Subject: Material for today's Light-duty GHG NPRM discussion.

Summary points from EPA review of CAFE model (NPRM version) – Effect of EPA code revisions

Meeting with Office of Management and Budget/OIRA

Figure 6 Incremental Effectiveness of TURBO1 to TURBO2 (MedSUV class)

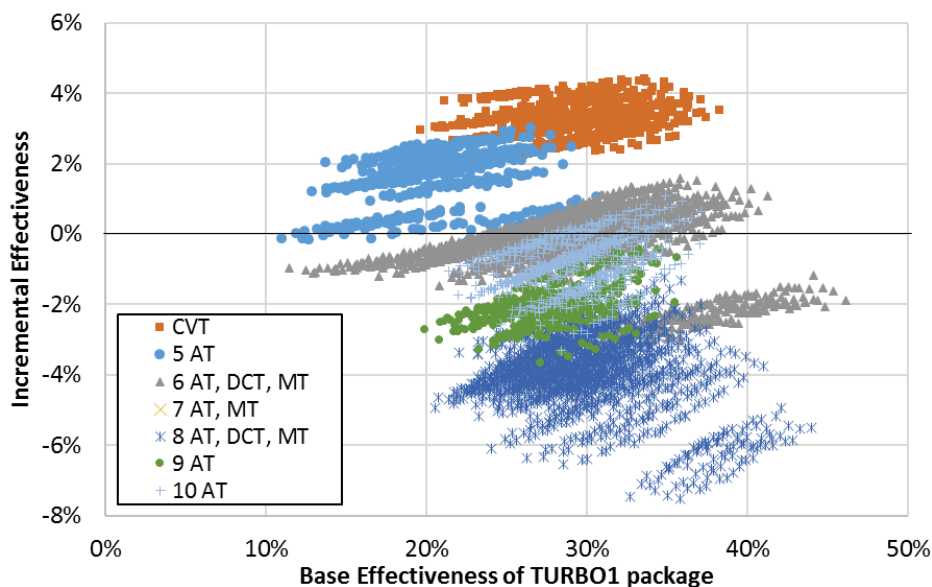
The technology inputs include two levels of turbocharged engines, TURBO1 and TURBO2. The incremental cost of TURBO2 hardware over TURBO1 hardware is about \$350 to \$700 in 2030; although it is unclear what specific technologies are represented by this cost, one would expect a generally higher effectiveness. However, depending on the package and car class, the actual incremental effectiveness values from the NHTSA technology inputs for the TURBO2 technology is often negative. The “Medium SUV” class, shown in Figure 8 has the most pronounced effect, with the addition of the TURBO2 technology, on average, having a negative effectiveness.

Figure 7 Incremental Effectiveness of TURBO2 to CEGR1 (MedCarPerf class)

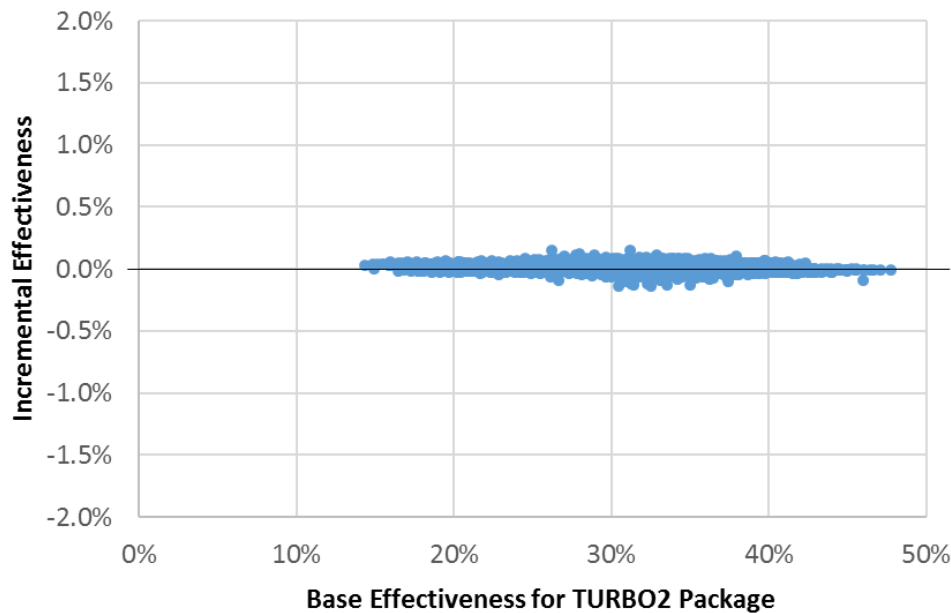
A cooled EGR package when added to the advanced turbocharged engine (TURBO2) has a cost of \$334 in 2030. Cooled EGR is a technology that has been used in the market, and has a significant effect on CO₂ reduction. However, as illustrated in Figure 9, the incremental effectiveness is at or near zero for nearly all packages (and averaging zero for all packages). The “Medium Car Performance” class shown in the figure is representative of the near-zero effect of the technology for all classes.

Figure 9: EPA Observations of Transmission Effectiveness

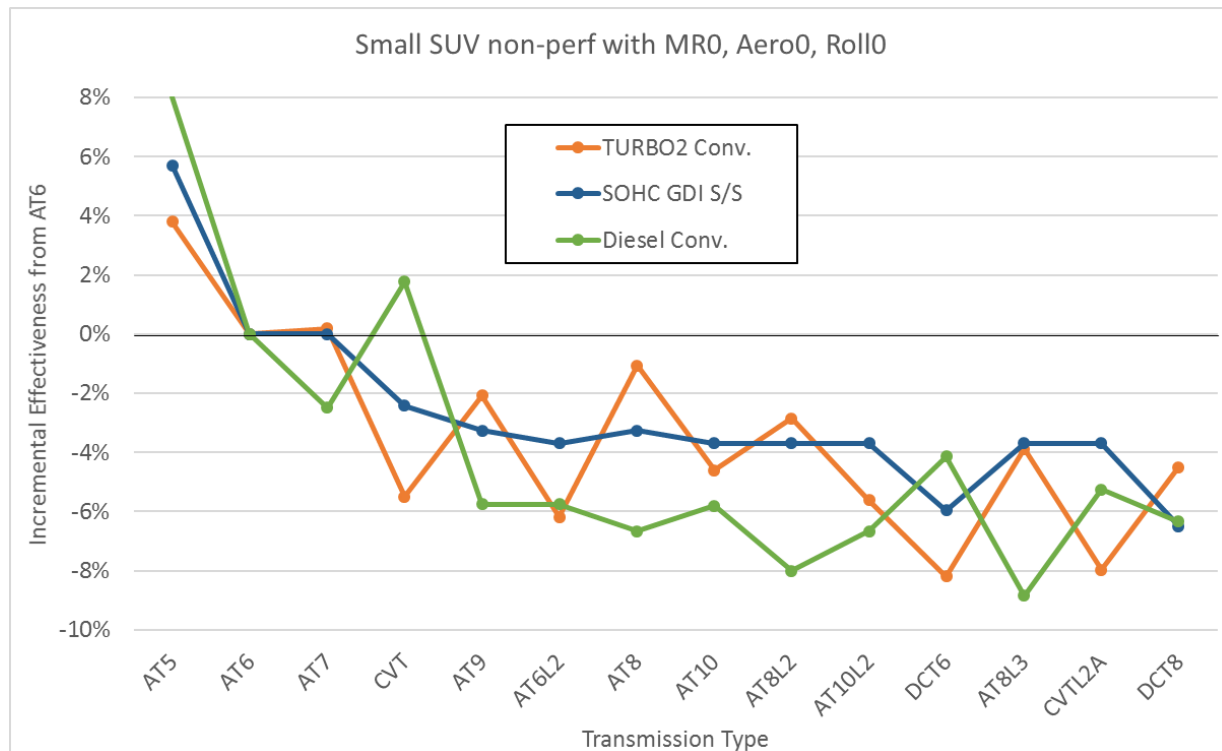
As part of the review process with NHTSA, NHTSA requested additional information and specific examples of vehicle technologies that did not follow the logical progression of transmission technology and commensurate effectiveness. In response EPA provided Figure 9: EPA observations of transmission effectiveness below. This figure shows that as advanced transmission technologies are applied to several powertrain types, there are instances where the more advanced transmission demonstrates lower effectiveness than the less advanced transmission. In addition, to this chart EPA also provided the exact technology package references from the CAFE model inputs. As of this summary, NHTSA has not yet responded to this observation.

Figure 11 Incremental Effectiveness of 48V Mild Hybrid with belt-integrated starter-generator (BISG) to crank-integrated starter-generator (CISG) (Small Car class)

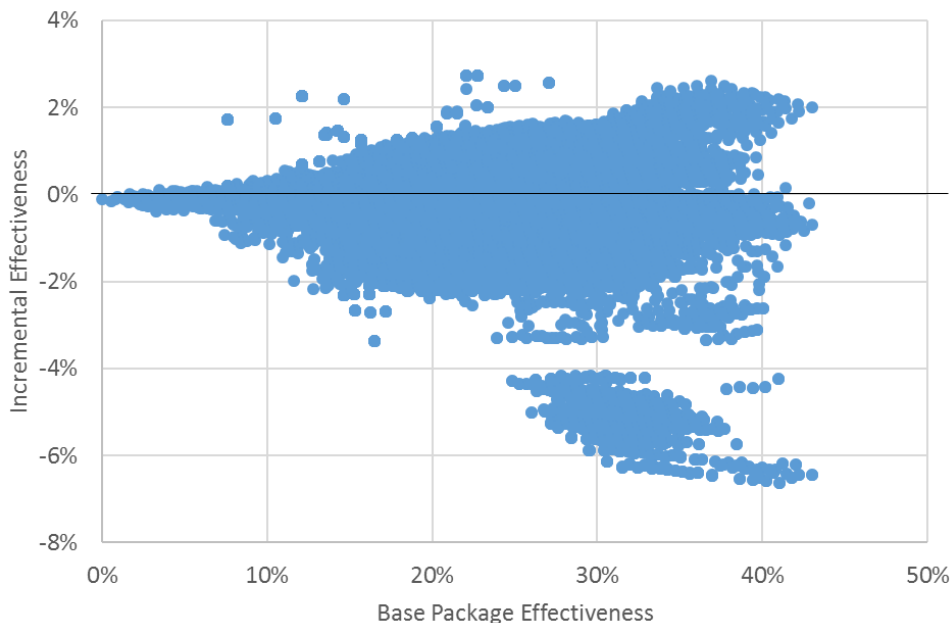
However, on average, the CISG is slightly less effective than the BISG, although with a wide spread of effectiveness. The small car example shown in Figure 12 is typical, with the incremental effectiveness of most packages between about +1% and -1%.

Figure 12: EPA’s Observations of Negative Effectiveness for Start/Stop Packages

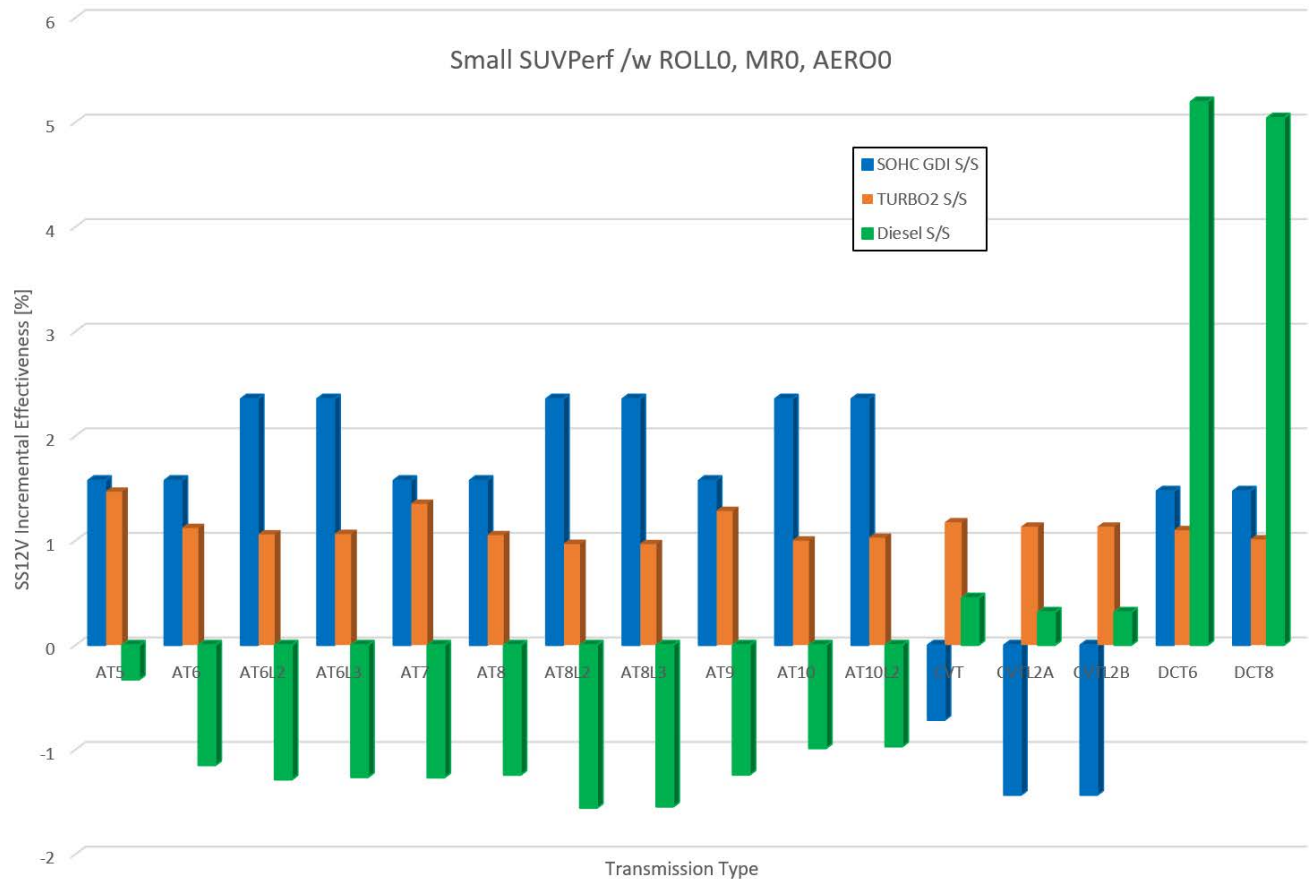
In addition to examples of unexpected transmission effectiveness estimates, NHTSA also requested examples of observed negative 12V start-stop effectiveness. In Figure 12: EPA's Observations of Negative Effectiveness for Start/Stop Packages, below, EPA has identified 12V start/stop packages that demonstrate negative effectiveness. These results are not rational. There are not situations under which turning off the engine instead of allowing the engine to idle would result in increased fuel consumption. In addition, for those packages with the same engine and positive effectiveness, it is also unexpected to observe such large variation in start/stop effectiveness. A SOHC GDI S/S should consume the same amount of fuel at idle independent of being mated to an AT8 transmission or an AT8L2 transmission.

Figure 13 Incremental Effectiveness of CONV to SS12V for Small Car class (left) and Medium SUV Perf class (right)

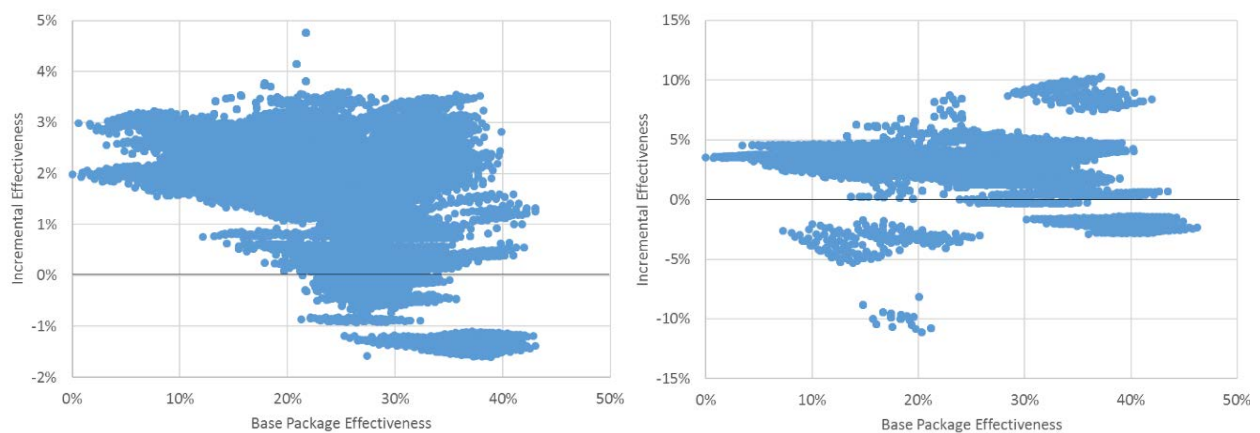
The cost of stop-start technology is either \$466 or \$521 in 2030, depending on vehicle class, plus about \$582 in battery costs. However, there are some packages where the provided technology inputs indicate a negative effectiveness, as shown in Figure 13 for the small car class below. Moreover, there are a few packages in some classes that are clear outliers (see the medium SUV performance class), either high or low.

Figure 18 Comparison of NHTSA mileage accumulation schedule with data from other sources for cars (left) and trucks (right)

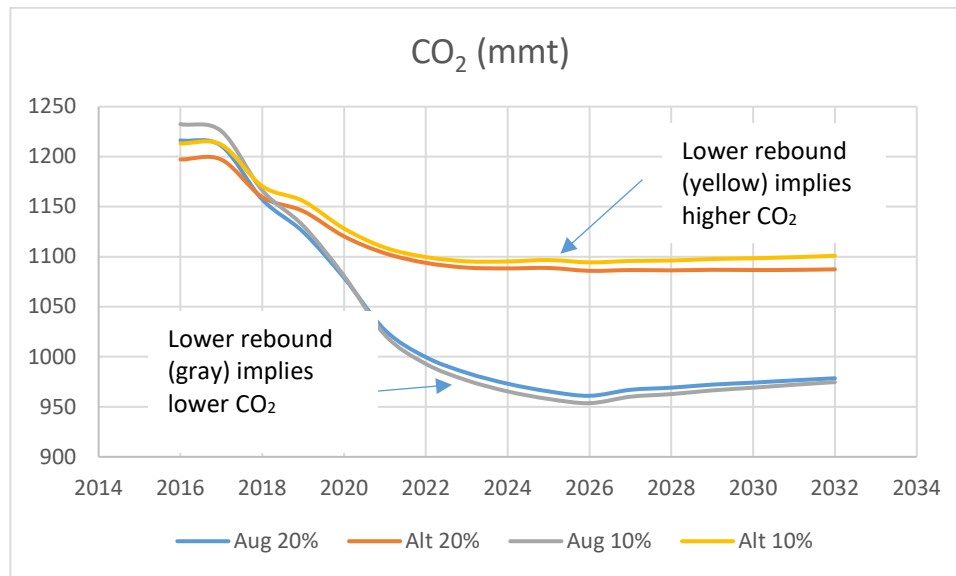
The table of vehicle miles traveled (VMT) by vehicle age described in the 'parameters' input file shows a steep drop-off in annual VMT after age 6. NHTSA had first utilized a curve with that shape in the 2016 Draft TAR, and EPA understands the underlying data source is an IHS/Polk product based on odometer readings from individual vehicles. The drop-off in annual VMT in the NHTSA schedule shown in Figure 16 is not seen in other data sources, including the 2001 National Household Travel Survey (NHTS), and a DOE LBNL analysis based on odometer readings from DMV records of the Texas inspection and maintenance program. The 2009 NHTS data shows a decline that coincides with the NHTSA schedule, but of a much smaller magnitude.

Question/Information Request 13. Can NHTSA provide an explanation for why such a dramatic decline in annual VMT occurs after age 6, and considering that large decline why does NHTSA believe that the IHS/Polk data is more defensible than multiple other sources which are based on population-weighted samples of odometer readings of individual vehicles.
